# Hove Gardens, Hove Section 73 - Pre-App Report - NMA

July 2021  
CJCT  
Section 73 Report  
Planning Ref: BH2020/00917  
Rev 04

## Brief & Summary of Changes

## 1.2 Basement Floor Plan - Proposed

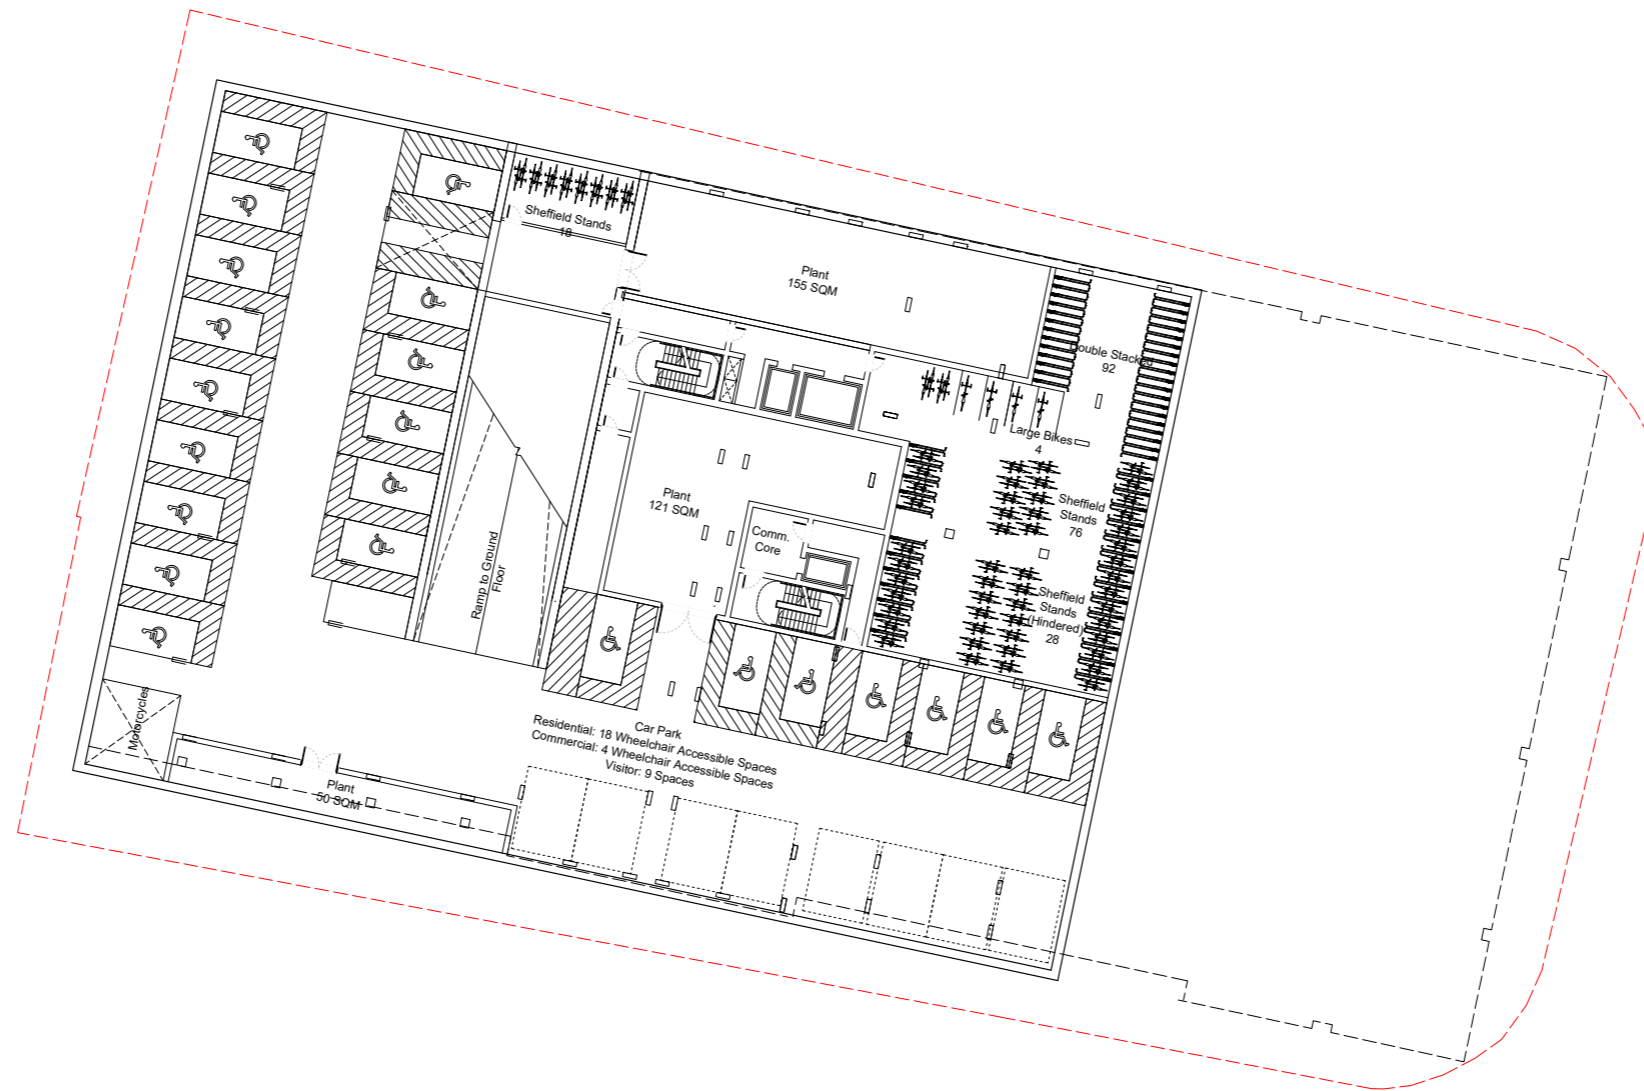
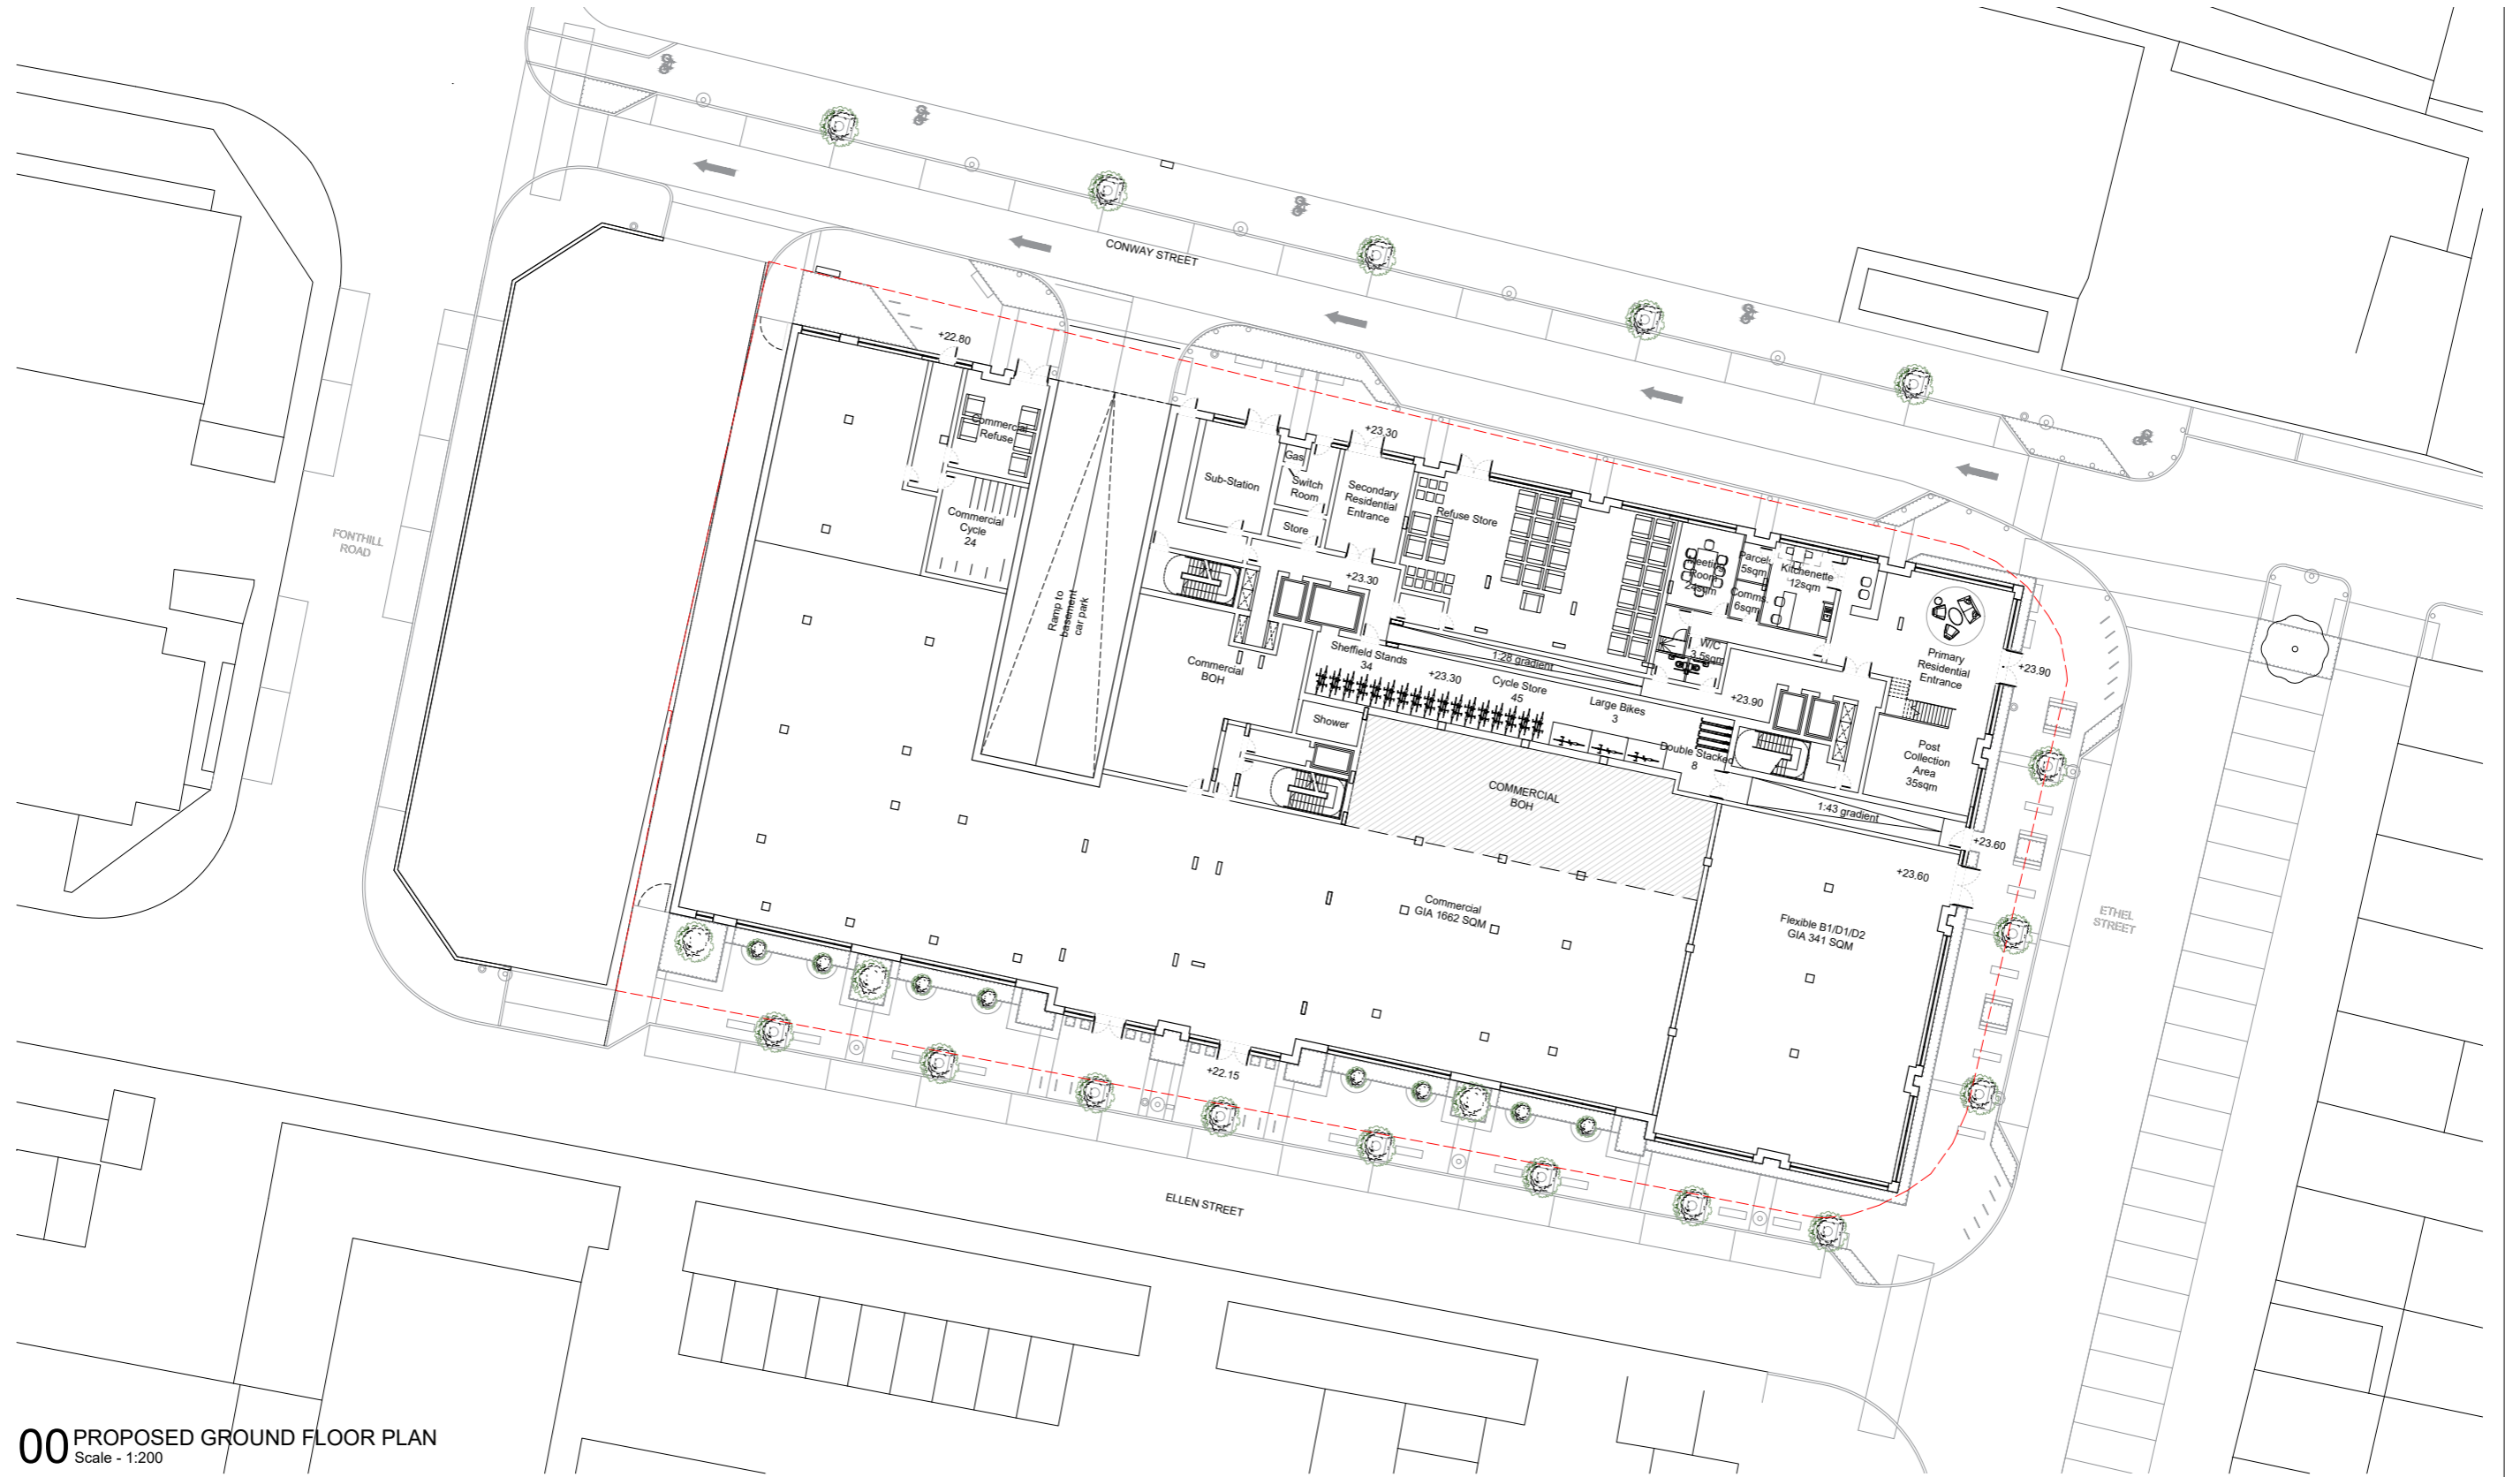
- ① Removal of slab voids to deck access
- ② Columns added to support weight of projecting deck
- ③ Balustrading updated to vertical railing
- ④ ASHP's located on level 7 roof
- ⑤ Updated ground floor layout to improve active frontage and maximise commercial offering. Dedicated Commercial Refuse Storage
- ⑥ Updated basement layout following full MEP and structural optimisation - Improved cycle storage
- ⑦ Updated landscape proposals to accommodate basement ventilation
- ⑧ Anodized Aluminium Panels
- ⑨ Dark Stone at Base
- ⑩ Omitted juliet balcony
- ⑪ Aluminium fascia at balconies
- ⑫ Solid Metal Panel to be welded to the backside of the metal railing balustrade

## 2.2 South Elevation - Proposed

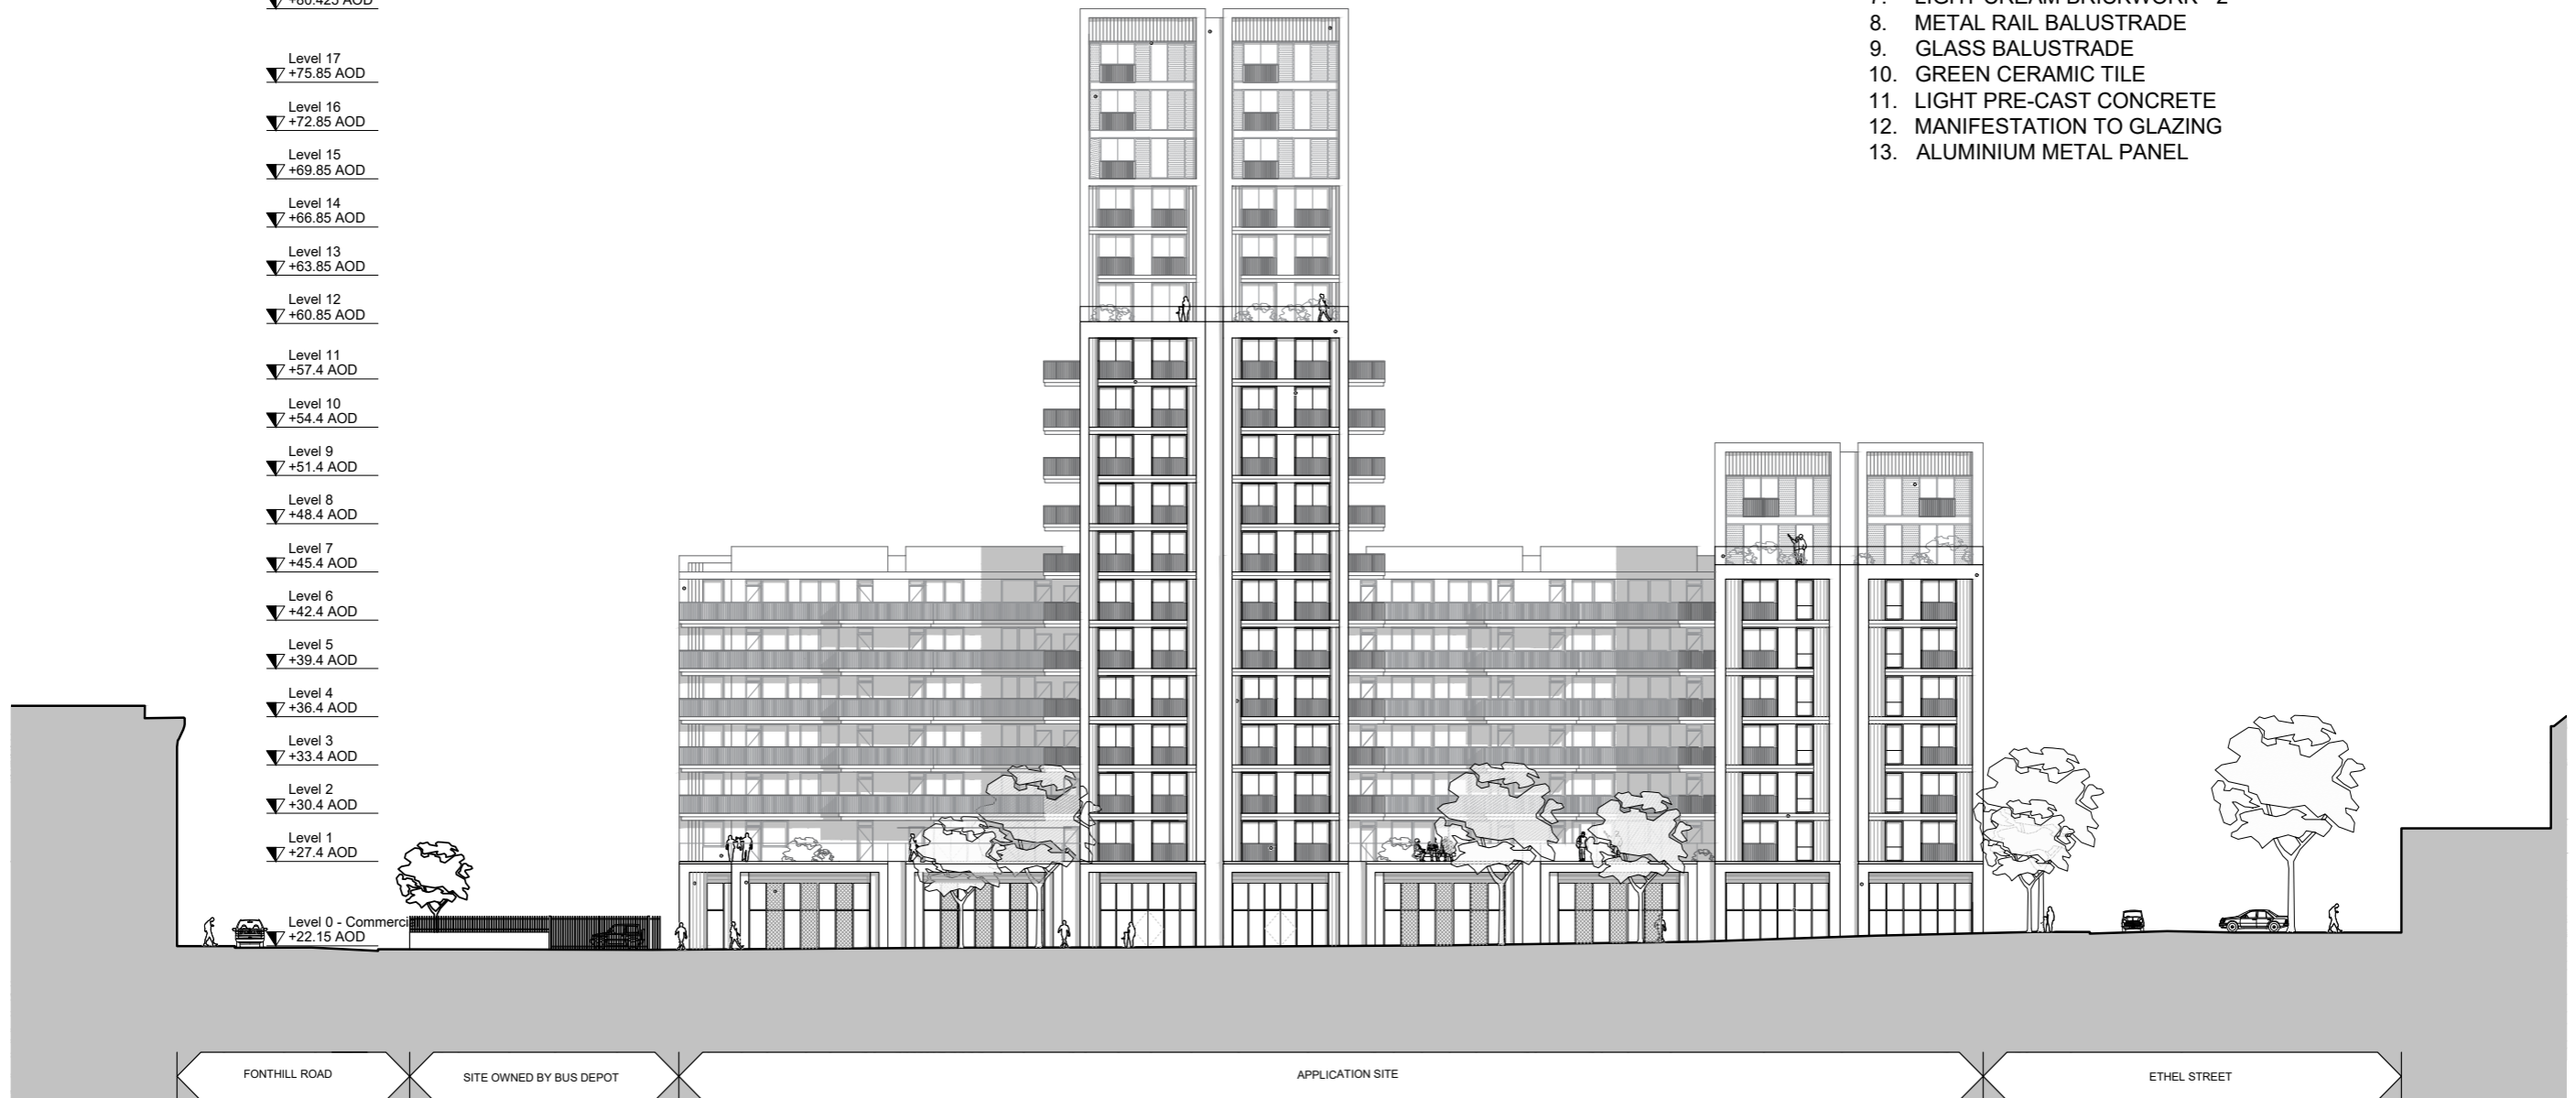
- ① Removal of slab voids to deck access
- ② Columns added to support weight of projecting deck
- ③ Balustrading updated to vertical railing
- ④ ASHP's located on level 7 roof
- ⑤ Updated ground floor layout to improve active frontage and maximise commercial offering. Dedicated Commercial Refuse Storage
- ⑥ Updated basement layout following full MEP and structural optimisation - Improved cycle storage
- ⑦ Updated landscape proposals to accommodate basement ventilation
- ⑧ Anodized Aluminium Panels
- ⑨ Dark Stone at Base
- ⑩ Omitted juliet balcony
- ⑪ Aluminium fascia at balconies
- ⑫ Solid Metal Panel to be welded to the backside of the metal railing balustrade
